Comment on ExQ1-Q1.2.3. 40-year lifetime

Comment on ExQ1-Q1.4.1. Electricity storage

Comment on Q1.4.2 – Single Axis Tracker (SAT) configuration

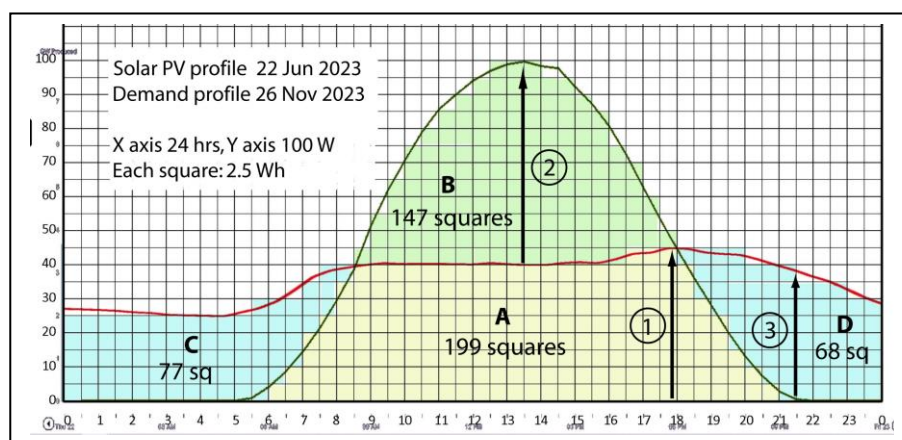
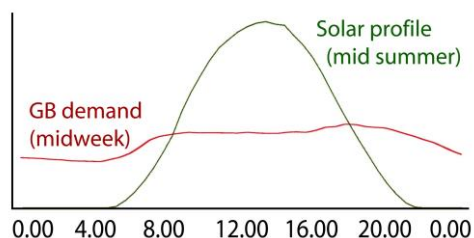
Fortunately, this is easy to work out if you remember A Level Physics. Copy power profiles of maximum solar output (June) and grid demand from one of the websites that show graphical representations of published data. Superimpose the graphs and scale them such that they have equal area under the curves (= energy).

In the bottom graph, the y-axis (power) is arbitrarily assigned to 100 W, and hence each square on the paper represents 2.5 Wh. Area **A** is solar energy that can be fed directly to the grid, while surplus **B** is stored in the battery for subsequent discharge to **C** and **D**.

Measuring off the graph, the required battery capacity **B** (= **C+D**) is 367.5 Wh.

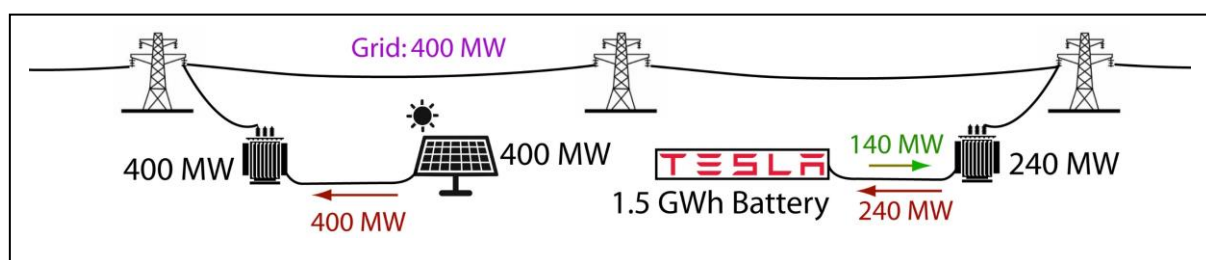
Reading off the graph again and scaling up for a 400 MW system, the peak charge rate (arrow ②) is 240 MW and the peak discharge rate (③) is 140 MW. For an installation with a remotely located battery, the system design looks like this:

The full 400 MW from the solar array/inverters is sent to the grid via a 400 MVA transformer. The battery substation requires a 240 MVA transformer (max charge rate).

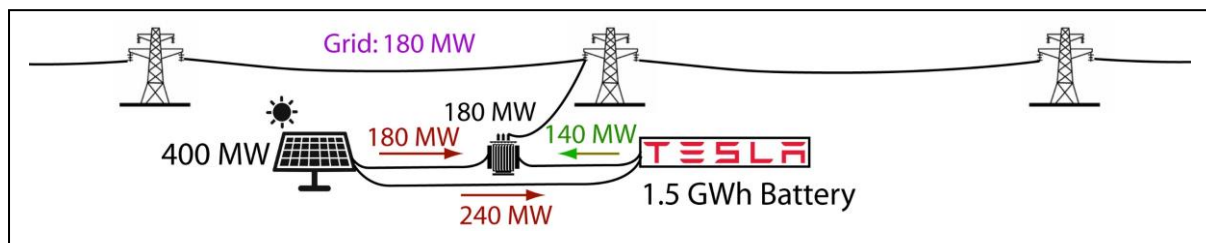
The design is a lot simpler when the battery and solar array are co-located:

The peak output power is now 180 MW (① in the graph), so a single 180 MVA transformer is all that is required. More significantly, you can give the overstretched National Grid the good news that you now need only 180 MW grid entry capacity.

Again, this is theoretical. I think the Megapack needs 480V 3φ interfacing, so there's another transformer.

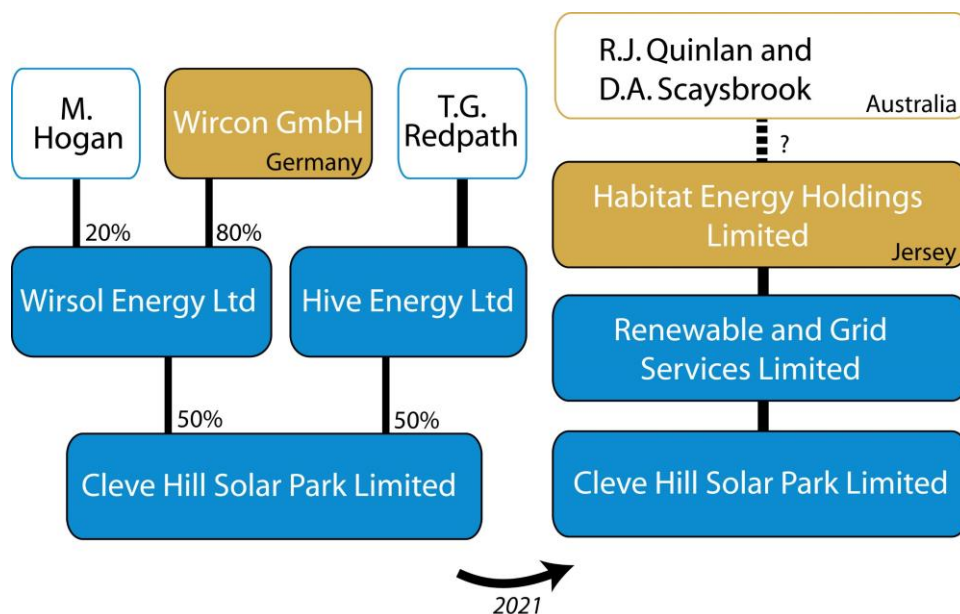
ES Climate Change quotes 922 kWh/kWp/yr as both the minimum yield [6.4.5] and the typical yield [6.7.30]

A more meaningful expression of the units would have been kWh/yr/kWp, because they are describing annual energy (kWh/yr) per kWp of PV panel.

For comparison, the government publishes measured solar PV Load Factors¹. The most recent available value is 11.4% for 2022 (excluding PV connected during 2022). The figure is based on Installed Capacity, but includes some estimates so may not be entirely accurate. Many UK solar farms are several years old now, so the newer ones should actually have higher LF figures. All (?) use fixed south-facing panels.

11.4% equates to 999 kWh/yr per kW installed. (24 x 365 x 11.4%)
